Replacement Requirement for Components within the High-Voltage Battery 2.0: No Mixed Installation of Components Permitted (06/24)

Vehicle Type: **Cayenne E-Hybrid (9YA / 9YB) / Cayenne S E-Hybrid (9YA / 9YB) / Cayenne Turbo E-Hybrid (9YA / 9YB)**

Model Year: **2024**

Concerns: **Need for replacement of the components listed below within the high-voltage battery 2.0**

Affected components on upper level of high-voltage battery

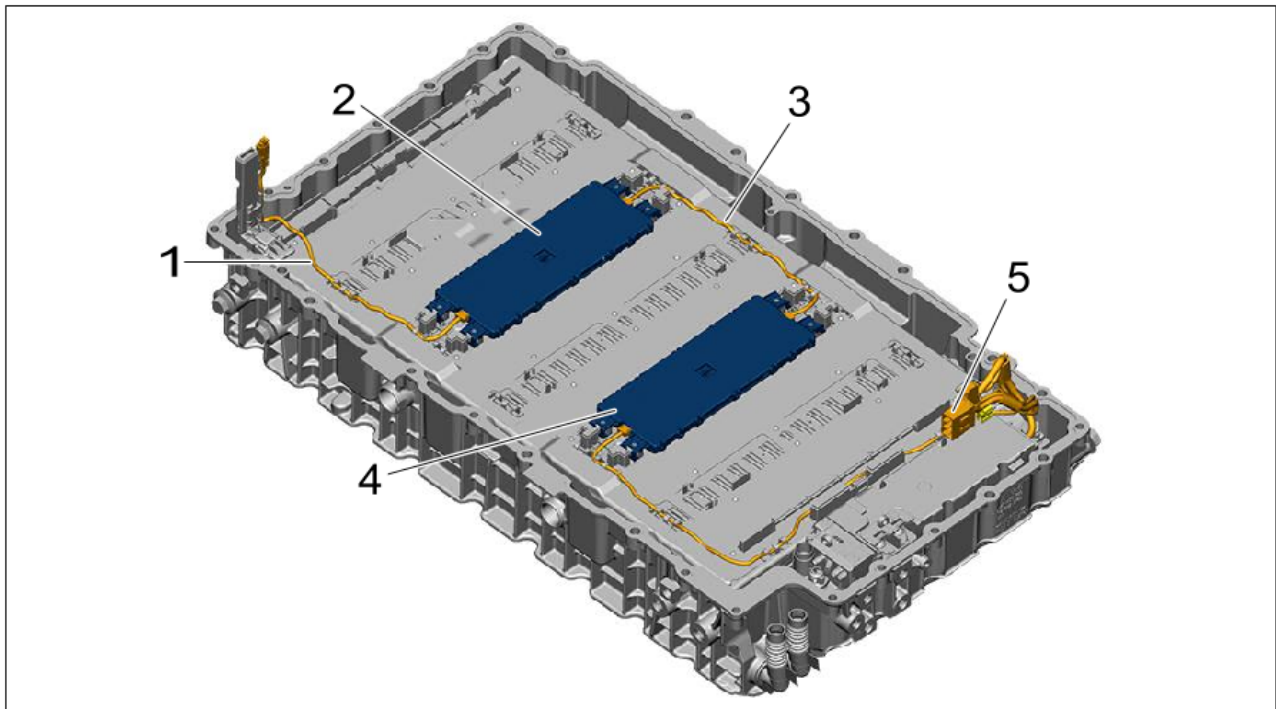
Cause: **In the high-voltage batteries installed ex works in model year 2024 (R), the above-mentioned components are designed with tin-plated plug contacts. As part of a material change, the available original parts of the respective components from the warehouse have been converted to gold-plated plug contacts.**

The **new components** equipped with **gold-plated plug contacts** must **not** be used in a mixed installation with the **previous tin-plated component statuses** in the event of replacement, as otherwise contact corrosion on the plug contacts can occur due to the different materials.

Position	Designation	Part number – Gold contact
⇒ Affected components on upper level of high-voltage battery -1-	Wire harness	PAB915901C
⇒ Affected components on upper level of high-voltage battery -2-	Circuit board	PAB915115B

⇒ Affected components on upper level of high-voltage battery -3-	Adapter cable	PAB972546A
⇒ Affected components on upper level of high-voltage battery -4-	Circuit board	PAB915115C
⇒ Affected components on upper level of high-voltage battery -5-	Plug holder including wire harness	PAB915703C

Action: If **one** of the components within the high-voltage battery 2.0 specified in the following section ⇒ *Technical Information 'Overview of affected components'* is required, **replace all affected components with tin-plated plug contacts with new components with gold-plated plug contacts.**
